### NEDO-33173-A, Revision 1, Applicability of GE Methods to Expanded Operating Domains

NEDO-33173-A  
Revision 1  
DRF 0000-0012-1297  
DRF Section 0000-0123-0447  
Class I  
September 2010

# **Applicability of GE Methods to Expanded Operating Domains**

**SUBJECT: FINAL SAFETY EVALUATION FOR GE HITACHI NUCLEAR ENERGY AMERICAS, LLC LICENSING TOPICAL REPORT NEDC-33173P, "APPLICABILITY OF GE METHODS TO EXPANDED OPERATING DOMAINS" (TAC NO. MD0277)**

**Figure 4-1 Void coefficient vs. instantaneous Void Fraction for a Range of Historical Void Fractions at an Exposure of 30 GWd/MT**

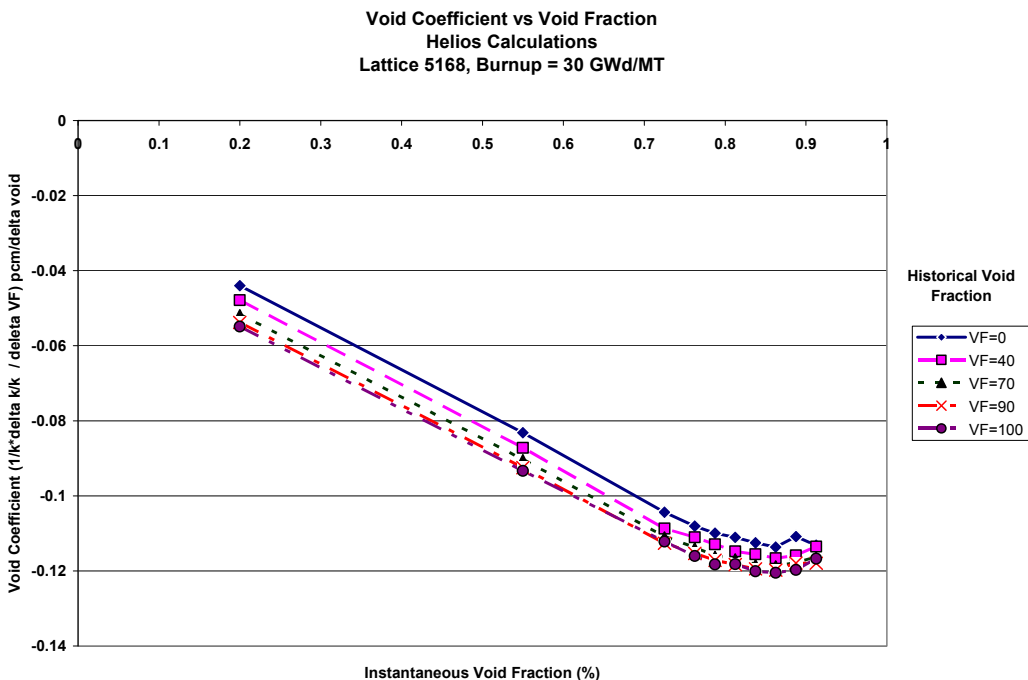
Comparisons of the void reactivity coefficients for the different void history cases and exposures based on ORNL HELIOS calculations are presented in Figure 4-1 and Figure 4-2. Note that additional instantaneous branch points were calculated at the higher void conditions to resolve the non-linearity of the void coefficient with respect to IV fraction at high fuel exposures. The impacts of the different void histories are evident at the higher void fractions with the increasing differences in the void reactivity profiles with increasing exposure. The difference in the profiles [ ] represents a potential error resulting from GE's methodology. The errors for exposures of about 30 GWd/ST and less are consistent with the [ ] assumed in the ODYN analysis. However, for higher exposures at high void fractions the error increases [ ]. In addition, the deviation of the void reactivity from a linear variation represents an error that results from the quadratic extrapolation used in GE's methodology. As shown in these figures, at high void fractions and high exposures the profile deviates from linear.

**Figure 5-1 Impact of Bypass Voiding on Peak Pin Fission Rate**

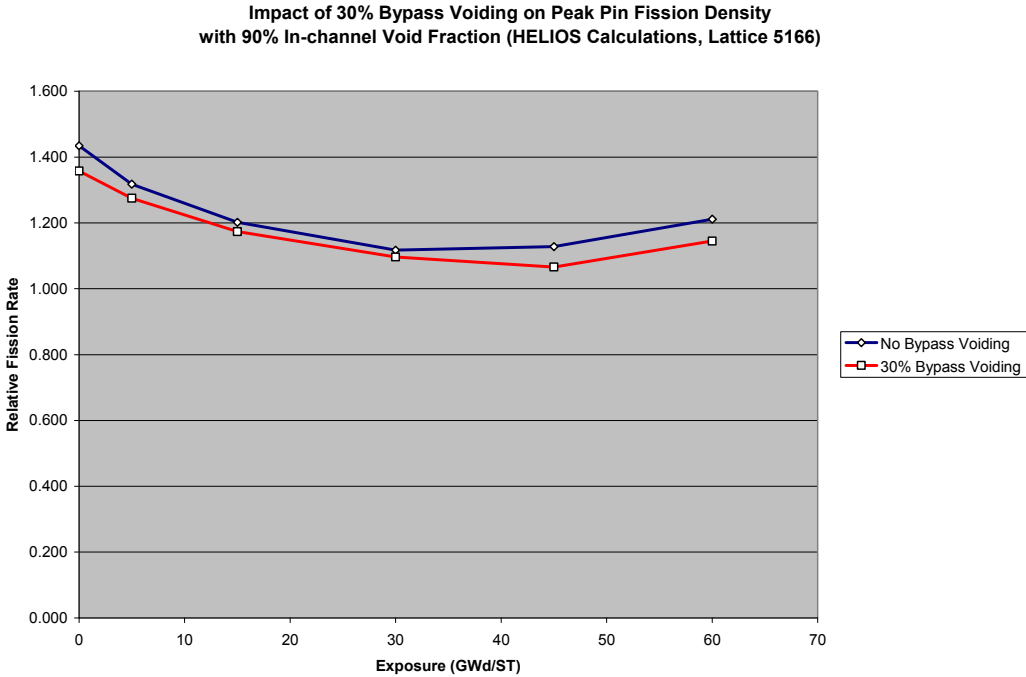
Figure 5-1 provides a comparison of the peak relative pin-fission rate for 90 percent in-channel void fraction with and without a 30 percent bypass void fraction. Figure 5-2 provides a similar comparison, but based on an RMS of the difference of the relative pin-fission rates from unity. This later parameter provides an indication of the overall "flatness" of the lattice pin power distribution. The results indicate, as discussed above, that the peak pin-fission rate is reduced and the lattice pin-fission rate distribution is more uniform (flatter) for the case with bypass voiding. Therefore, as far as lattice peaking is concerned, bypass voiding does not have a negative impact. In addition, the 30 percent bypass voiding considered greatly exceeds the maximum value of 5 percent indicated by GE for steady-state operation.

Figure 7-6 Void Fraction-Quality Relation with Partial Length Rods at Low Flow

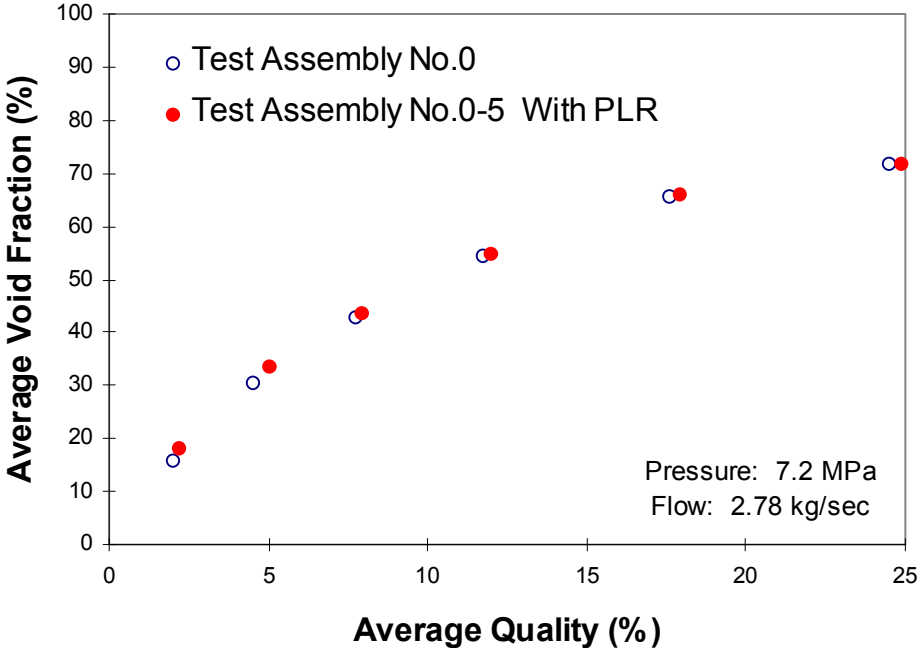
GE presented three plots showing the effect of partial length rods on void fraction (Response to RAI 5.2, Reference 9), which are shown as Figure 7-6 through Figure 7-8. The data in these plots were Japanese data taken from the open literature. The data indicates only a minor change in void fraction between bundles with and without partial length rods. GE noted that the void fraction correlation was not compared to this data because sufficient information about the test apparatus was not available. This limits the usefulness of data since there is no quantitative comparison with Findlay-Dix void that would allow the performance of the Findlay-Dix void-quality correlation to be evaluated for partial length rods.

by Table 7-2 (Table 2-8 of LTR NEDC-33173P (Reference 1)) and the trends shown in Figure 7-6 and Figure 7-7 (Figure 2-2 and Figure 2-3 of LTR NEDC-33173P (Reference 1)) over the entire range shown in the response to SRXB-A-69 (Reference 47) (See Appendix B) and validates this simple model for the drift flux.

Figure E-2. Percent change in DRC per 1 percent absolute change in void fraction

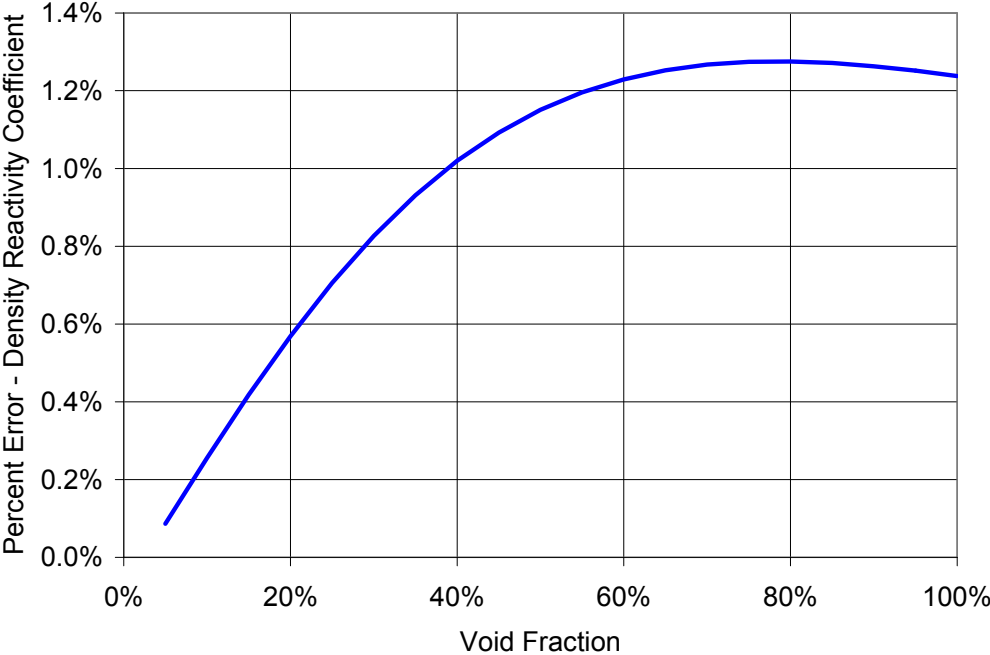
Appendix E contains an assessment of the impact of void fraction error on the value of the void reactivity coefficient. The results are shown graphically in Figure E-2 in Appendix E. As observed in this figure, the density reactivity change (DRC) error is a function of the void fraction, but it levels to an approximate value of 1.25 percent for void fractions greater than 60 percent, which is the range of interest. Therefore, the NRC staff concludes that a DRC error of 1.25 percent is a reasonable approximation of the error induced by a change in actual void fraction of 1 percent. For example, if the predicted void fraction is 70 percent, but the actual void fraction is 71 percent, the actual DRC is 1.25 percent higher than predicted. An error of the magnitude of the void fraction prediction by 5 percent could be approximated to result in 6.25 percent error in the density reactivity coefficient.
